MONTGOMERY COUNTY PLANNING DEPARTMENT
THE MARYLAND-NATIONAL CAPITAL PARK AND PLANNING COMMISSION

MEMORANDUM

SUBJECT: Mandatory Referral No. 09723-MCPS-01
Whetstone Elementary School Addition
Montgomery Village Gaithersburg Vicinity Master Plan

Attachment C Proposed Site Plan

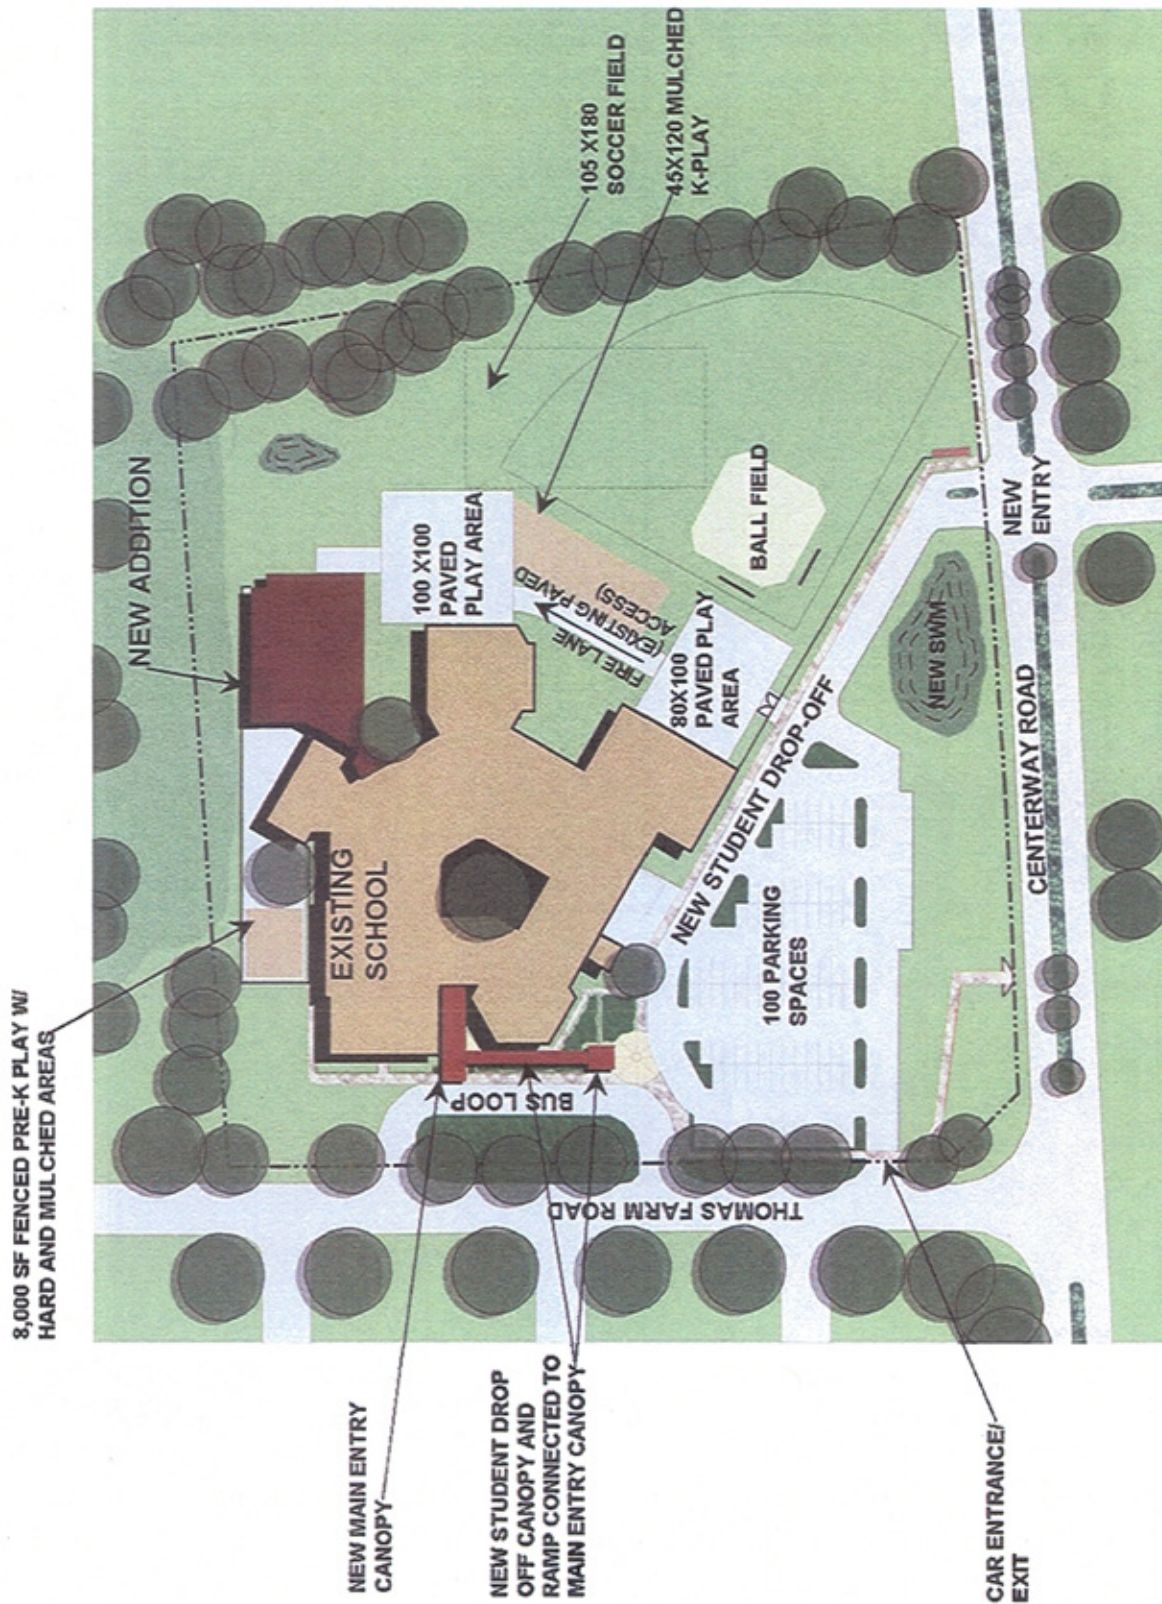
- a. **New Building Location:** The proposed, two story addition is oriented to the side and rear of the school extending from existing internal hallways. The new building's 40 foot setback from the side yard exceeds side yard setbacks found in most other residential zones. The proposed addition will extend further towards the existing community than the existing building setbacks along this side yard. Existing building setbacks range from 43 feet to 80 feet. The elimination of the mobile units is an improvement. See Site Plan, Attachment C.

- b. **Parking and Circulation:** The vehicular circulation of buses and cars is improved by the proposed plan. Buses are given a separate entrance from parking entrances and the student drop off area is expanded reducing congestion in the parking lot. A new entrance along Centerway Road that serves primarily the student drop off area will help reduce congestion at the intersection of Thomas Farm Road. The entrance is aligned with an entrance serving a recreation area managed by the Montgomery Village Foundation.

Pedestrian Circulation: The proposed plan provides for several sidewalk connections along Centerway Road and along the frontage of the school adjacent to the bus and student drop off areas. The new addition also has a perimeter sidewalk shown around the new building. Pedestrian access needs to be provided along Thomas Farm Road to improve safety for students and pedestrians along this street. And, a continuous sidewalk linking various existing sidewalk segments needs to be provided around the school to facilitate convenient access to ball fields and play areas.

Attachment D Proposed Landscape Plan

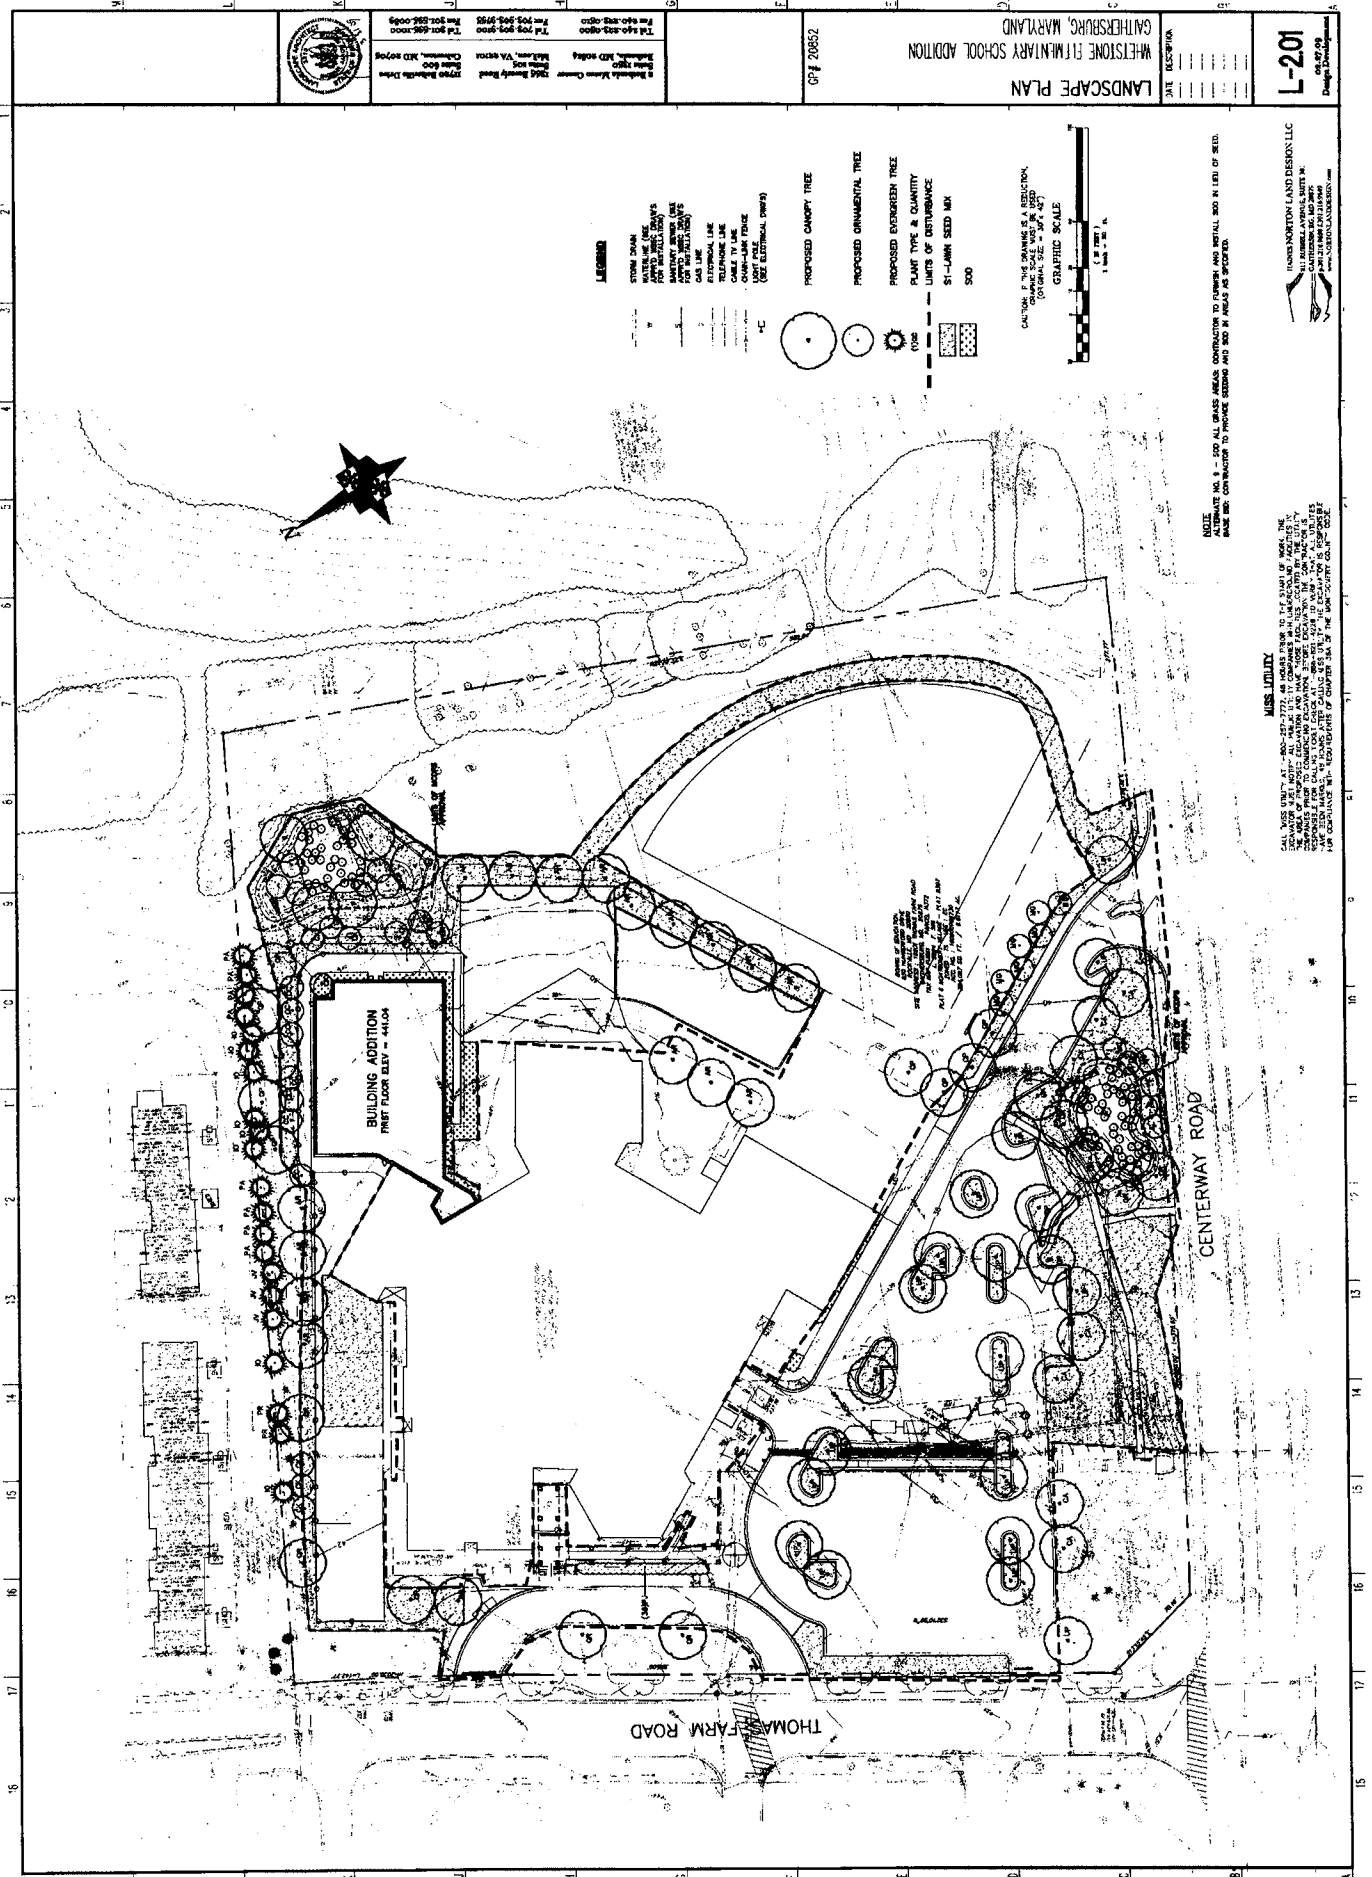
- d. **Landscaping and Lighting:** The proposed plan provides extensive on-site landscaping within the parking areas, along the side yard abutting the single family townhomes, and around the proposed stormwater management facilities. The plan will create an attractive setting for the school. Of particular importance, the landscape treatment along the side yard adjacent to the existing single family townhouses is extensive combining a double row of pines, oaks and maples to create a significant screen of the two story addition. See Landscape Plan, Attachment D.

The frontage of the site along Centerway Road is devoid of street trees even though further west along Centerway Road an established line of street trees exist. It is important to establish the continuity of a tree lined street and plant the front of the school site with street trees. The landscape Plans should be revised to show 11 street trees along the school's street frontage with a note that states: The exact location of the street trees to be determined in the field to fit existing conditions.

1. Provide 11 street trees along Centerway Road to continue the established line of street trees and show on revised landscape plan.
2. Provide a sidewalk along the school's frontage with Thomas Farm Road in coordination with MCDOT and MCDPS and continue a five foot sidewalk around the school to accommodate convenient pedestrian access.
3. Continue coordination with MCDOT and M-NCPPC to provide an administrative review of the traffic study. If the administrative review finds that the traffic study requires any changes to the proposed site plan, a revised mandatory referral application must be submitted.
4. Coordinate final decisions to preserve four existing trees identified on the Tree Save Plan as #7, #8b, #28 and #29 with M-NCPPC's Inspectors. If these trees cannot be saved, provide four, large caliper replacement trees and revise the Tree Save Plan.
